**Hurricane Sandy Repairs to the Newport Cliff Walk**

Bailey's Beach to Ruggles Avenue

ADDENDUM NO. 3 Prospective bidders and all concerned are hereby notified of the following changes in the Plans, Specifications, Proposal and Distribution of Quantities for this contract. These changes shall be incorporated in the Plans, Specifications, Proposal and Distribution of Quantities, and shall become an integral part of the Contract Documents.

REVISIONS			RHODE ISLAND	
NO.	DATE	BY	DEPARTMENT OF TRANSPORTATION	
1	3/4/13	KK	HURRICANE SANDY REPAIRS TO THE NEWPORT CLIFF WALK	
2	3/13/13	KK	NEWPORT, RHODE ISLAND	
			STANDARD DETAILS SHEET 2	
			CHECKED BY	DATE

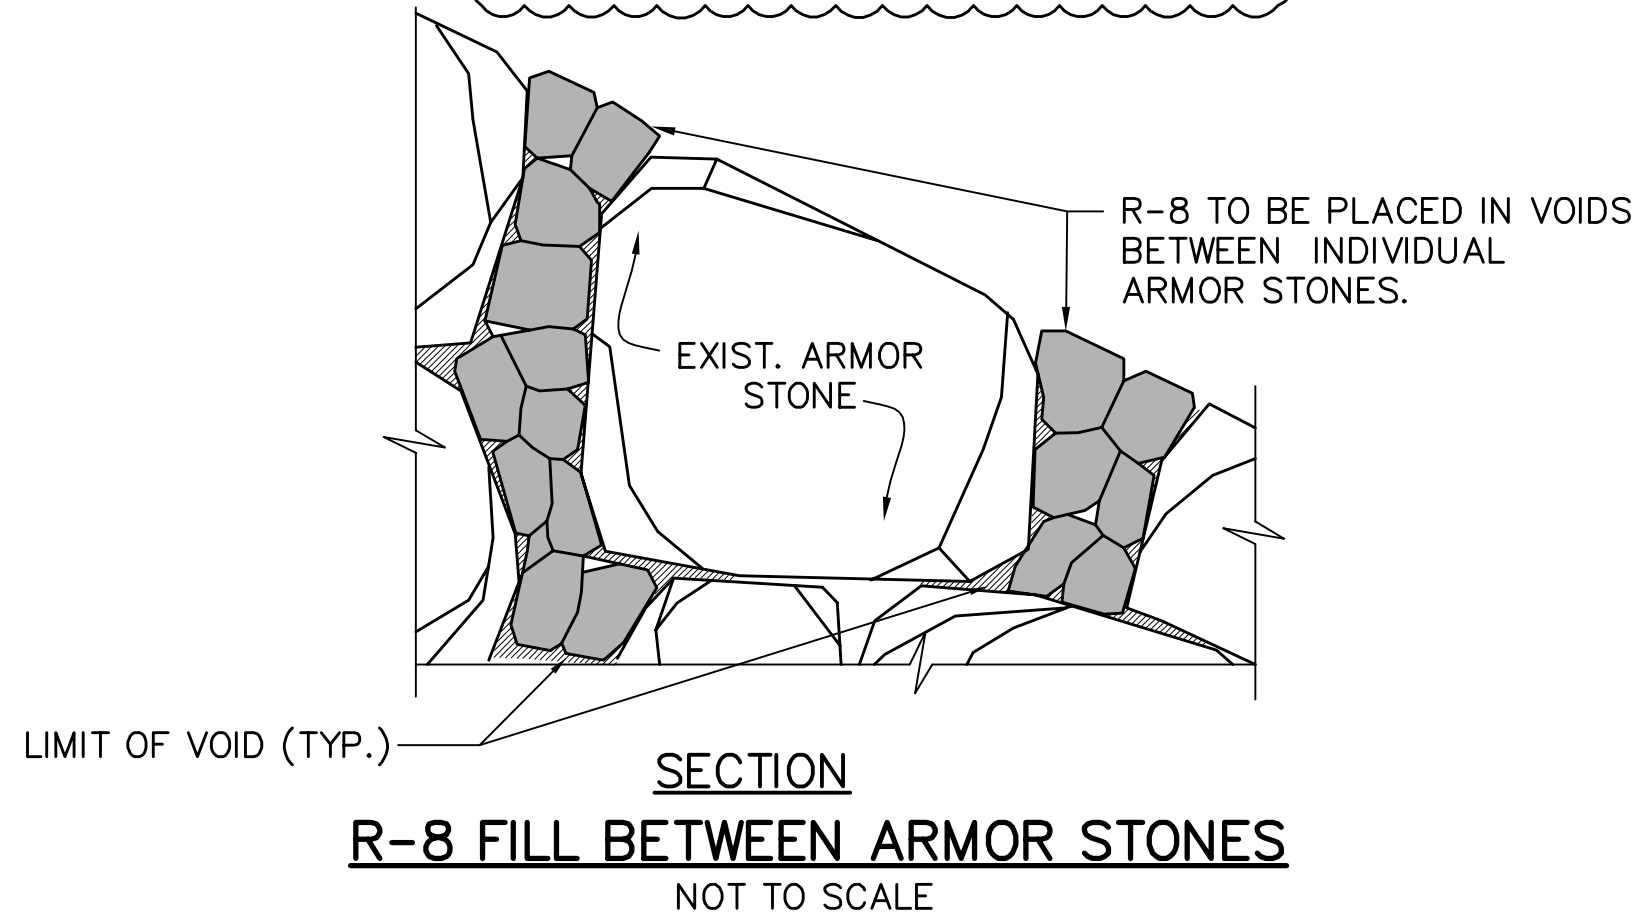
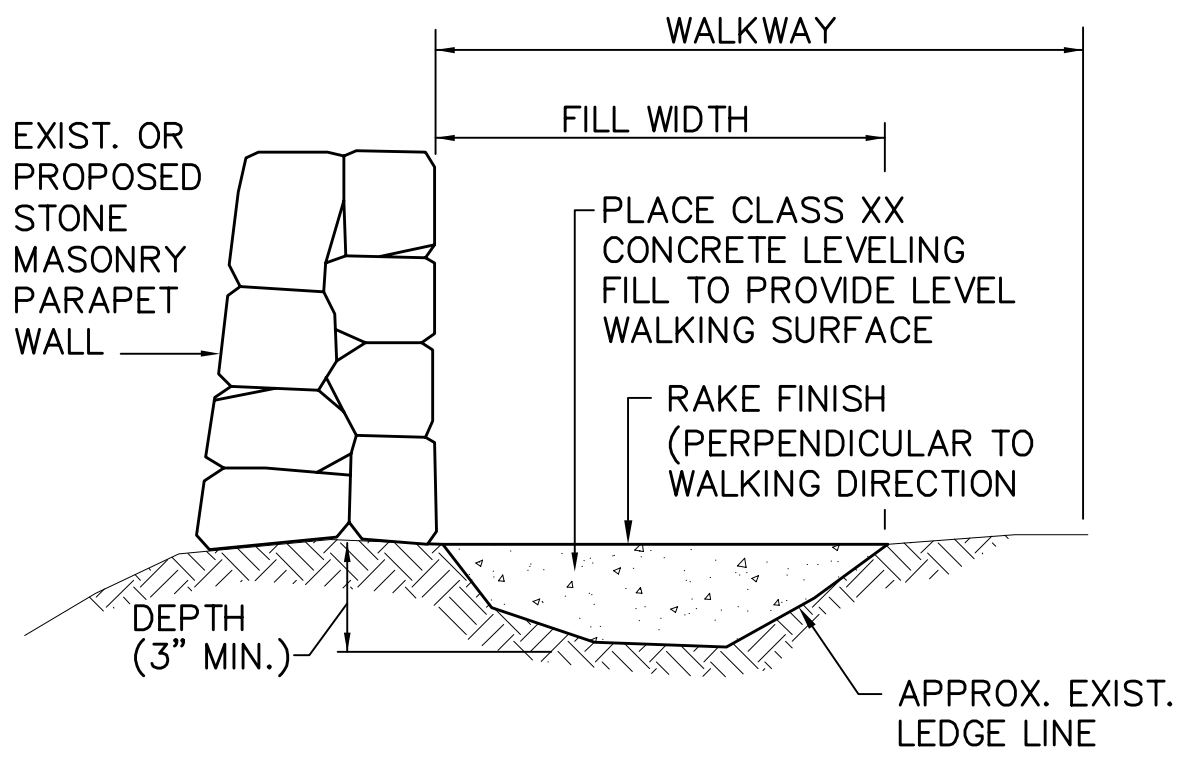
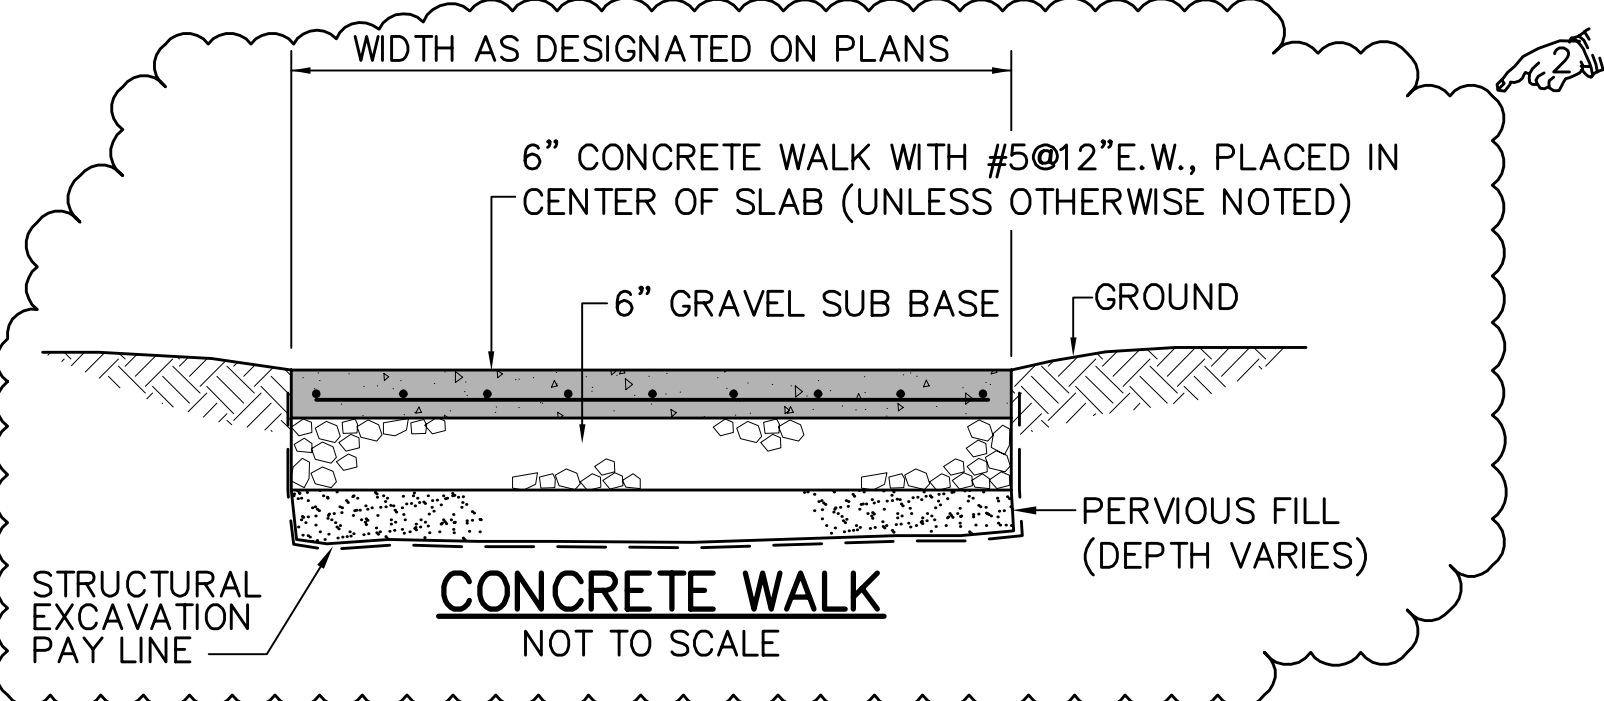
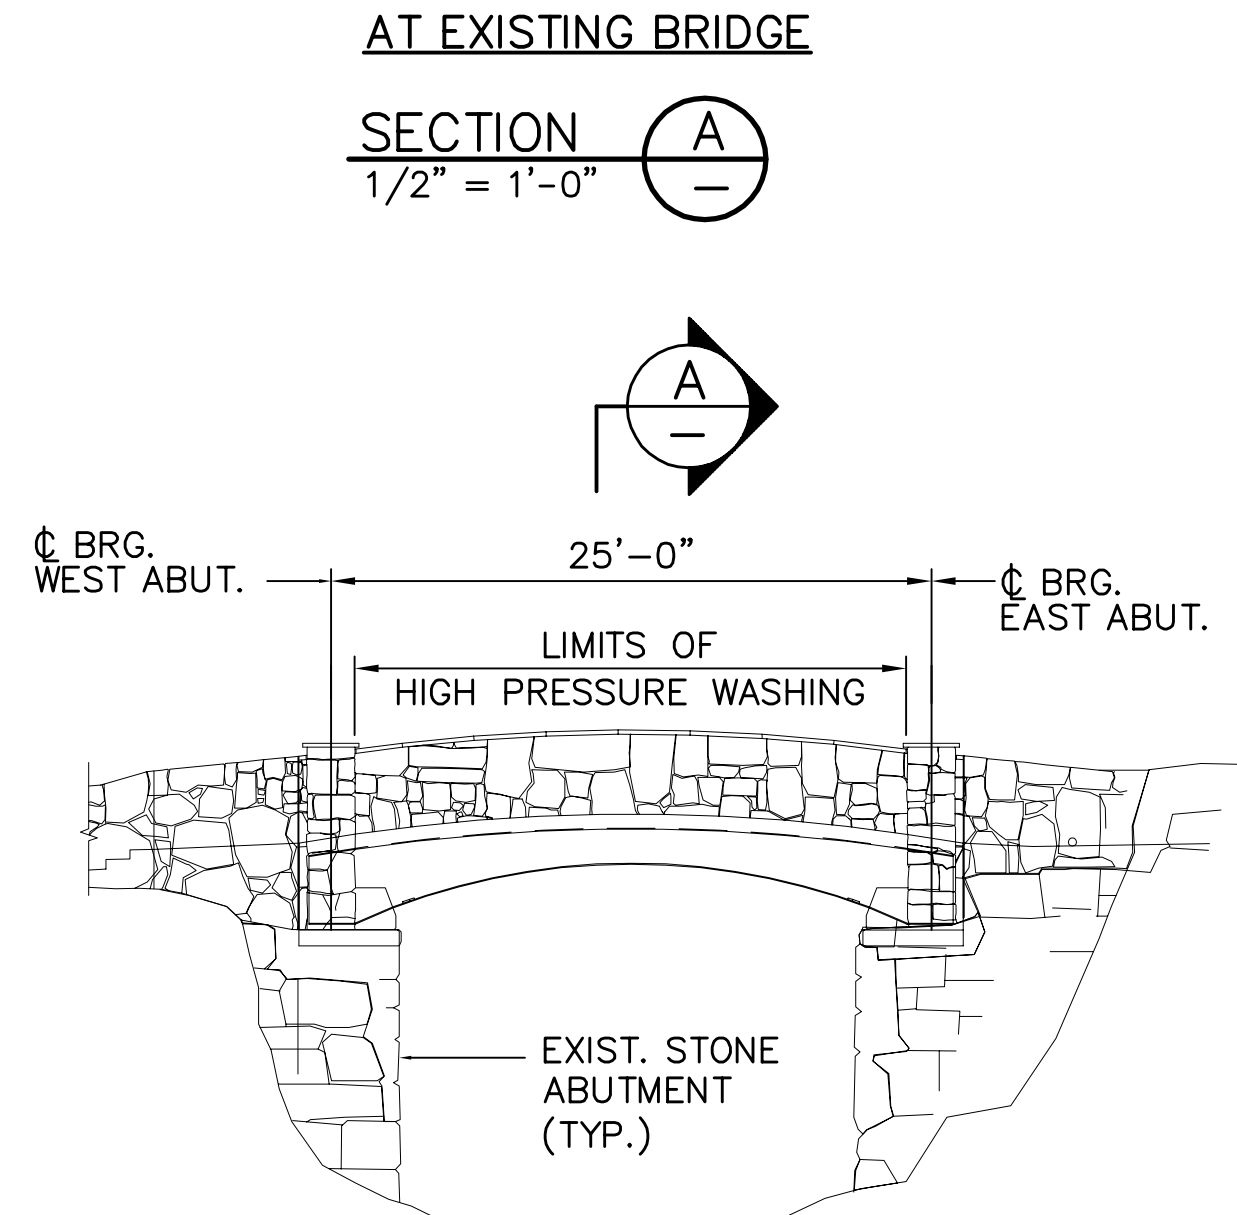
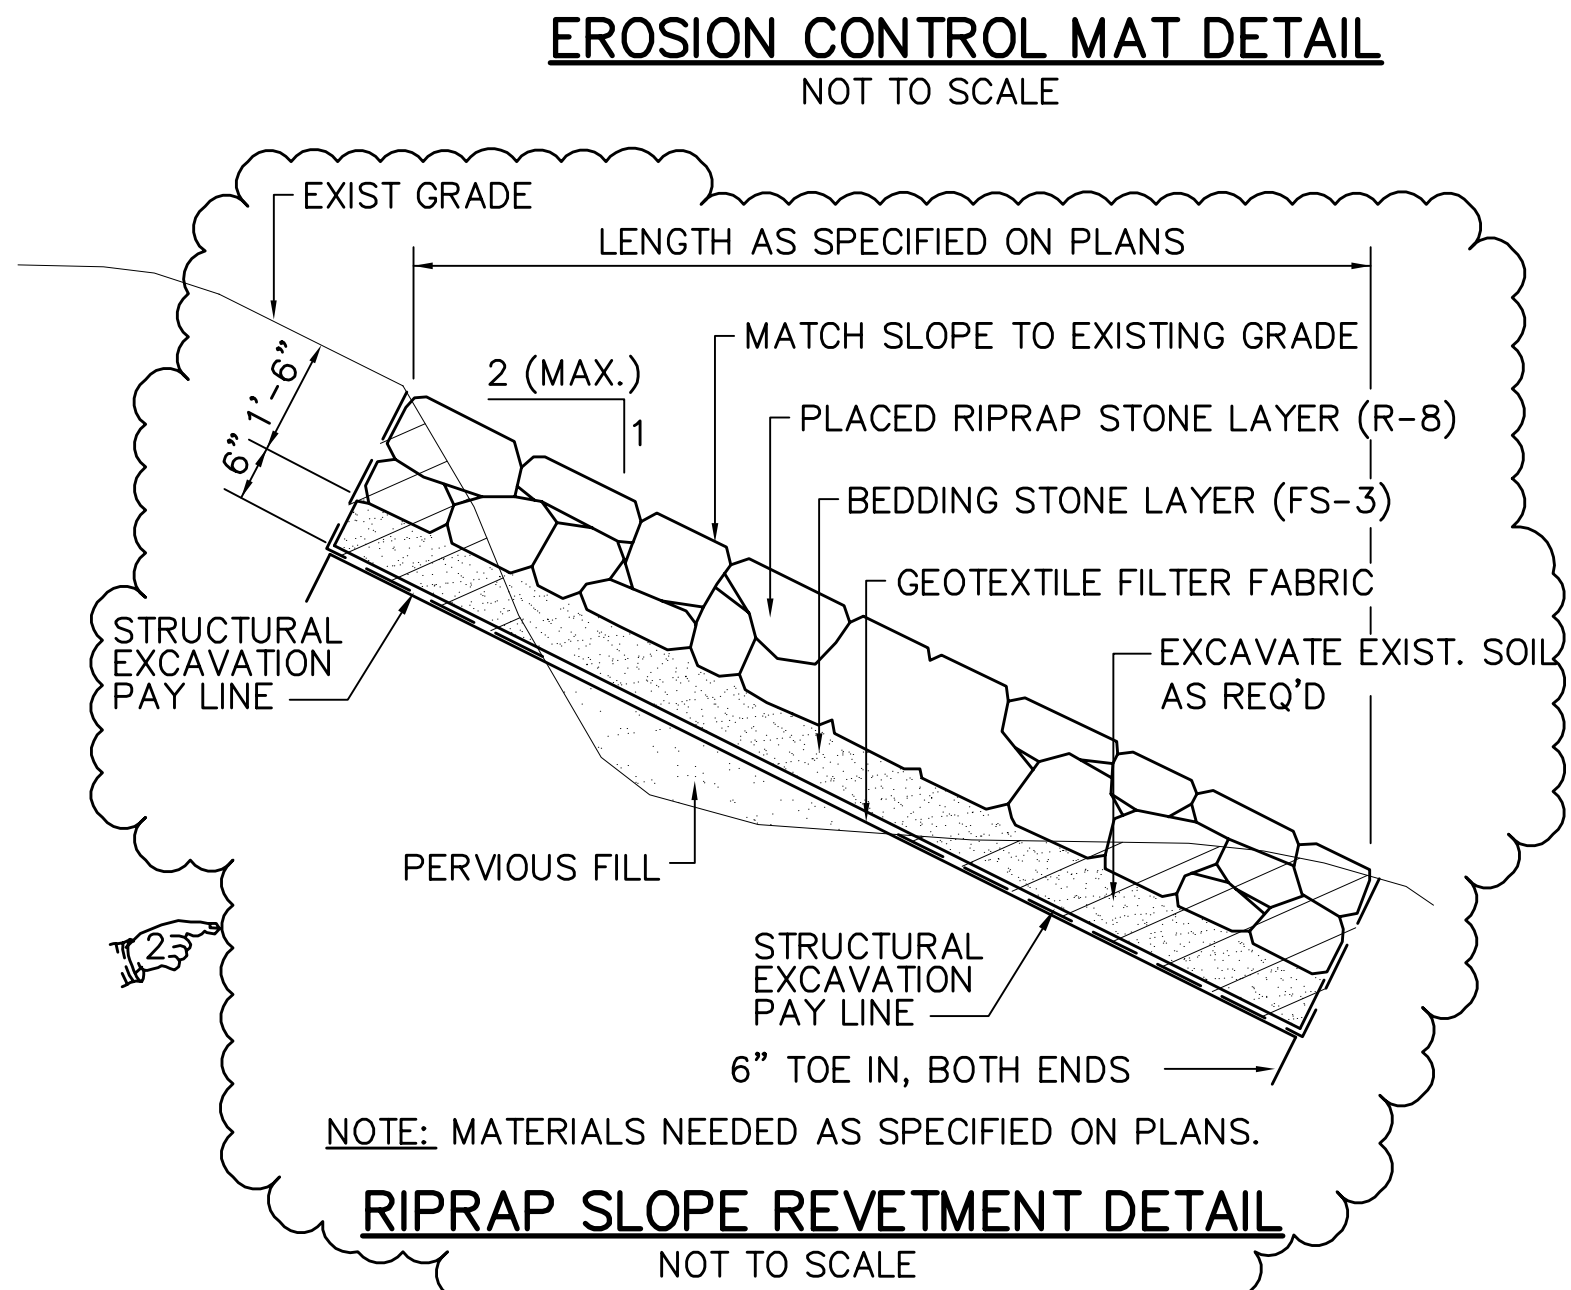
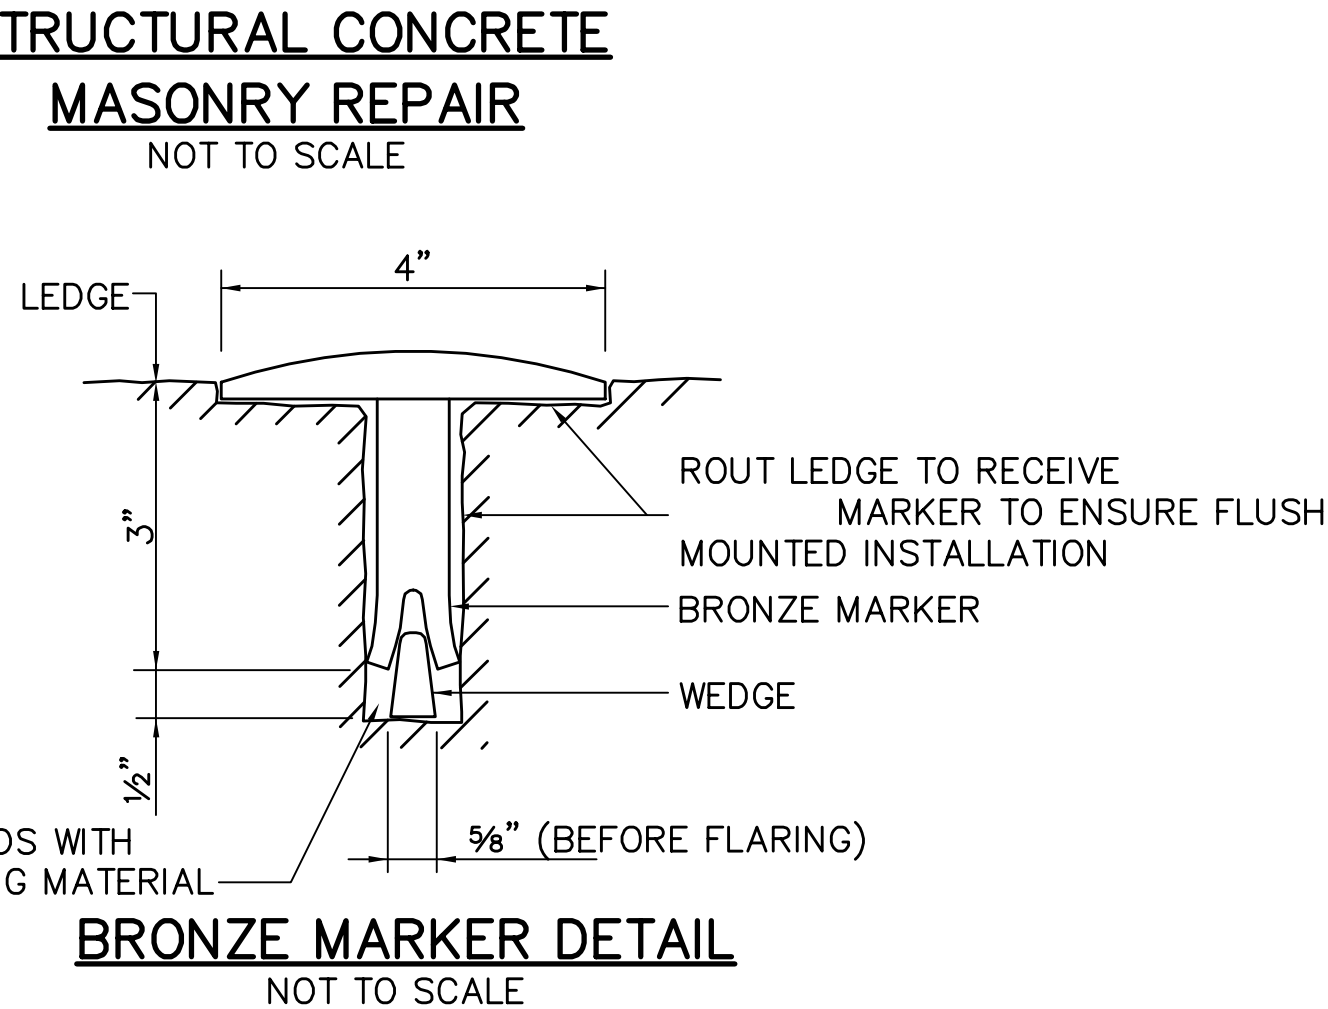
- 3. Sheet No. 5 (R-1) - Standard Details Sheet 2  
Remove Sheet No. 5 (R-1) in its entirety and replace it with revised Sheet No. 5 (R-2) attached to this Addendum No. 3. The "Transverse Expansion Joint in Conc. Walk" detail has been revised. The Concrete Walk, Stone Dust, Bituminous Walk details have been revised. The rip rap slope revetment detail has been revised.
